SUBJECT: ISSUANCE OF AMENDMENT NO. 62 TO FACILITY OPERATING LICENSE
NO. NPF-29 - GRAND GULF NUCLEAR STATION, UNIT 1, REGARDING
TECHNICAL SPECIFICATIONS REVISIONS - THERMAL HYDRAULIC STABILITY
(TAC NO. 71808)

AMENDMENT TO FACILITY OPERATING LICENSE

Amendment No. 62
License No. NPF-29

SAFETY EVALUATION BY THE OFFICE OF NUCLEAR REACTOR REGULATION

FIGURE 3.4.1.1-1 POWER-FLOW STABILITY REGIONS

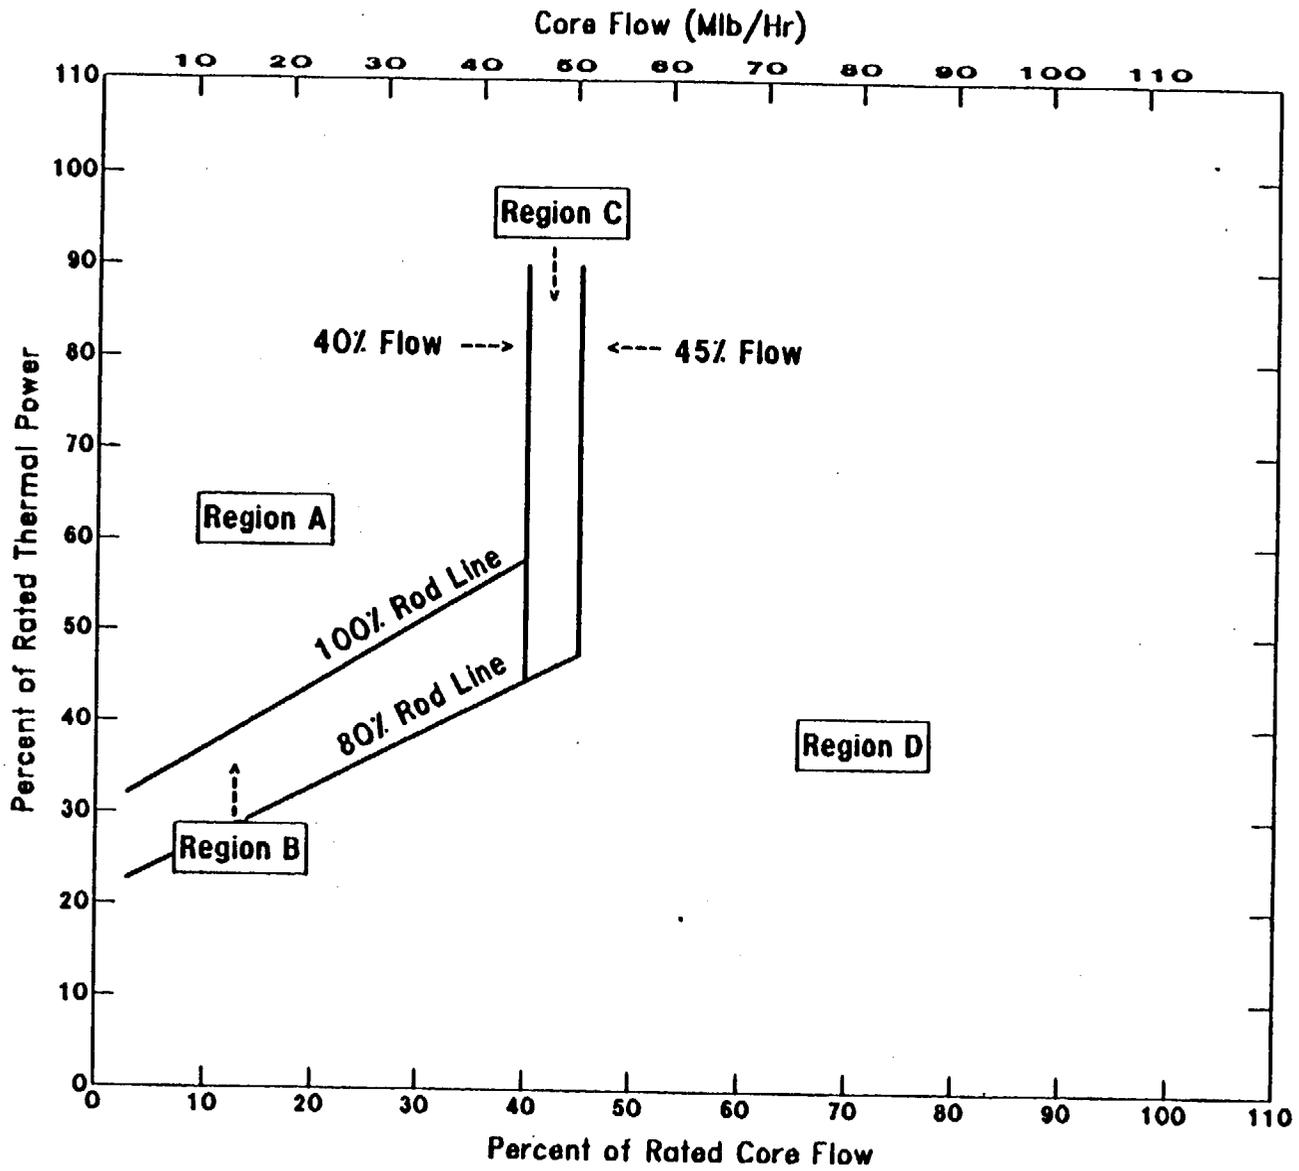
The amendment changes the TS by deleting TS 3/4.3.10, Neutron Flux Monitoring Instrumentation, and modifying TS 3/4.4.1, Recirculation System. Figure 3.4.1.1-1, Power Flow Operating Map, is changed to redefine flow stability regions. TS 3/4.4.1 is changed to reflect the redefined regions of Figure 3.4.1.1-1. The Bases for TS 3/4.3.10 and TS 3/4.4.1 are changed to reflect the changes in these TS.

Proposed changes to TS 3/4.4.1 affect only the sections relevant to THS (although the order of some other sections is changed). The primary changes are to Figure 3.4.1.1-1 altering the current region boundaries and designations so that they correspond to the IRSA regions. This changes the boundaries of current region I somewhat (and changes the designation to region C) and separates current region IV into IRSA regions A and B. The Specification prohibits operation in region A and B, and to some extent in region C. It requires, if the regions are entered, departure by scram in region A and by control rod insertion or flow increase (if a recirculation pump is operating at fast speed) in region B and C. (Bulletin, Supplement 1, allows entry into, and through, region C for flow increase departure from B.) Operation in region C is permitted for control rod withdrawals during startup for required fuel conditioning. (This would include restart or power increase from zero or low power conditions, but not other types of operations in region C, e.g., rod pattern exchange.) The TS also requires immediate scram, when the reactor mode switch is in the RUN position, when both recirculation pumps are not operating. (This does not include deenergizing during pump speed transfers.) This is in compliance with the staff request in the Bulletin Supplement.

Operation is not permissible in Regions A, B or C as specified in Figure 3.4.1.1-1 except that operation in Region C is permissible during control rod withdrawals for startup.

The power/flow operating map is divided into four (4) regions. Regions A and B are restricted from operations. They include the operating area above the 80% rod-line and below 40% core flow. Region C includes the operating area above the 80% rod-line and between 40% and 45% core flow. Operation in Region C is allowed only for control rod withdrawals during startup for required fuel preconditioning. Region D consists of the rest of the operating map. No core thermal-hydraulic stability related restrictions are applied to Region D since the potential onset of core thermal-hydraulic instabilities is not predicted within Region D.
